Mask and noise effects for SRn

Piers Dawe
Avago Technologies

Slow eye, mask at $5 \cdot 10^{-5}$

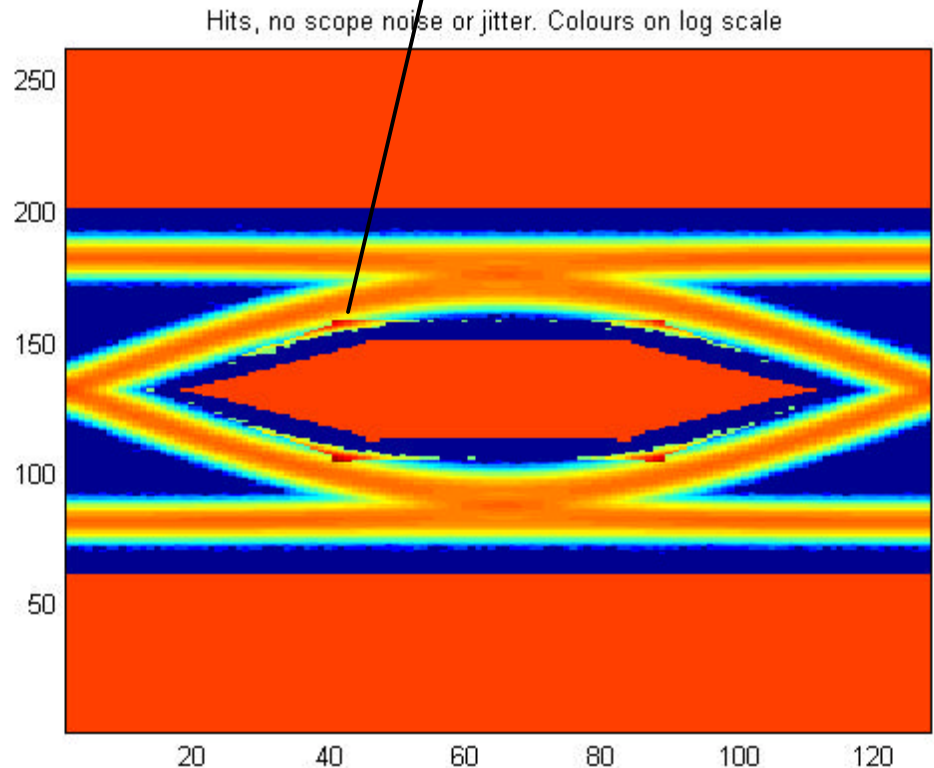
- Slow marginal eye at B:
 - Gaussian risetime 50 ps before a 12 GHz BT observation filter
 - SJ=0.02 UI
 - Vertical noise causes nearly all the apparent random jitter
 - TJ=0.284 UI
- Mask 0% coordinates are 0.14, 0.35, 90, 350
- Mask +25% coordinates are 0.105, 0.2625, 101, 319
- D1.1 coordinates are 0.12, 0.33, 95, 350
- D1.1 eye could be much worse than shown and still pass the mask
- John Petrilla proposes 0.12, 0.25

Note eye can be slower than mask and encroach corners significantly
